# UNITED STATES PATENT AND TRADEMARK OFFICE

APPLICATION NO.	FILING DATE	FIRST NAMED INVENTOR	ATTORNEY DOCKET NO.	CONFIRMATION NO.
10/547,204	08/26/2005	Uwe Zoller	SMB-PT155 (PC 04 019 B US	7991
3624	7590	07/20/2007	EXAMINER	
VOLPE AND KOENIG, P.C. UNITED PLAZA, SUITE 1600 30 SOUTH 17TH STREET PHILADELPHIA, PA 19103			BOECKMANN, JASON J	
		ART UNIT	PAPER NUMBER	
		3752		
		MAIL DATE		DELIVERY MODE
		07/20/2007		PAPER

<b>Office Action Summary</b>	Application No.	Applicant(s)
	10/547,204	ZOLLER, UWE
	Examiner	Art Unit
	Jason J. Boeckmann	3752

## DETAILED ACTION

Examiners marked up figure 6

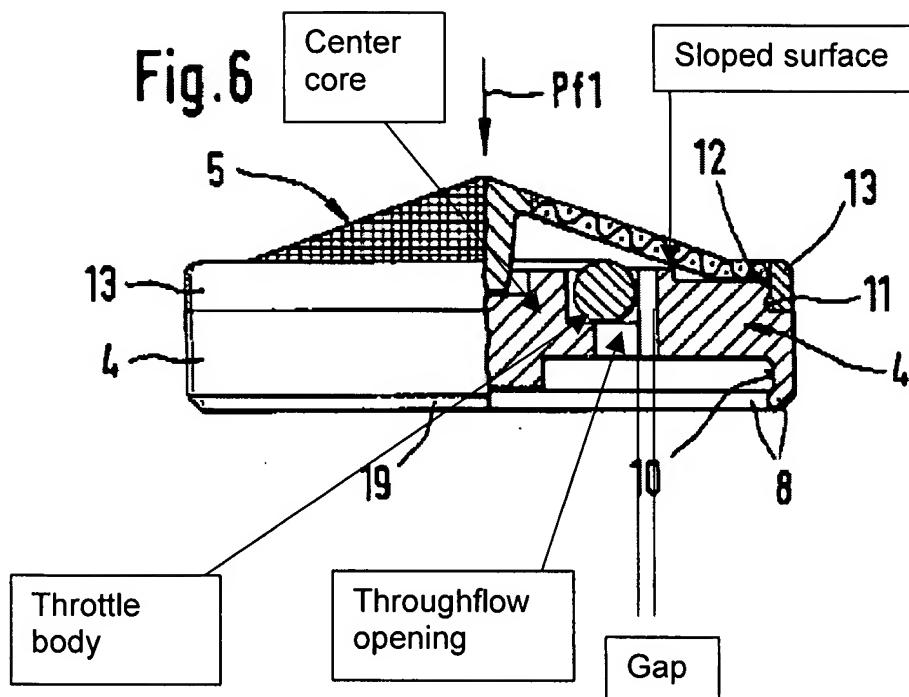
Regarding claims 3 and 7, the throughflow regulator has an exterior edge with a radially inward rising sloping surface (the top of the throughflow regulator where the surface steps up to substantially conform to the cross-section of the sieve (5) has a 90 degree inwardly rising sloped surface) which leads to a throughflow opening connected to a control gap (see examiners marked up figure 6 below). The control gap is also provided with a central core area which is surrounded by a throttle body and the rising sloped surface having a throughflow cross-section being adjustable by the throttle body.
